BIDDING ADDENDUM NO. 1

PARTIAL RE-ROOFING:

SHARPS CHAPEL ELEMENTARY SCHOOL
1550 SHARPS CHAPEL ROAD
SHARPS CHAPEL, TN 37866

BID 0086 – SCES ROOF

A5 | NEW TURBINE
VENT FLASHING

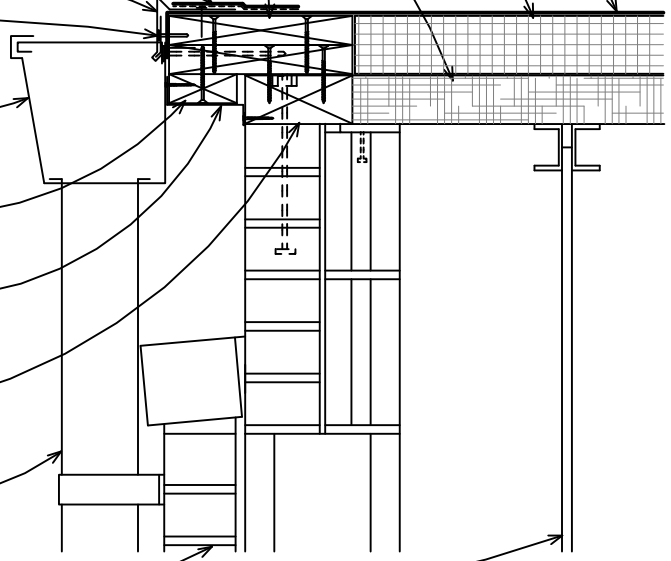
- a. Under Roof System Replacement insert "New Gutters (Alternate No. 2) Remove all existing gutters on Roof Areas A & B and replace with new 6" prefinished steel box gutters. Extend roof edge with new wood blocking & sheet metal flashing. See detail F10A/R2.1"
- b. Delete detail A5 and insert new detail A5 as shown on attached Revision Drawing RA-1.
- c. At detail F5 insert the following note at the gutter: "Remove existing Ogee gutter and replace with new 6" prefinished steel box gutter – Alternate No. 2".
- d. Insert detail "F10A/R2.1 Roof Edge @ Classroom & Gym w/ New Gutter (Alternate #2)". Reference attached Revision Drawing RA-2 for new detail F10A. Note detail F10A/R2.1 is for Alternate No. 2 only (new gutters).
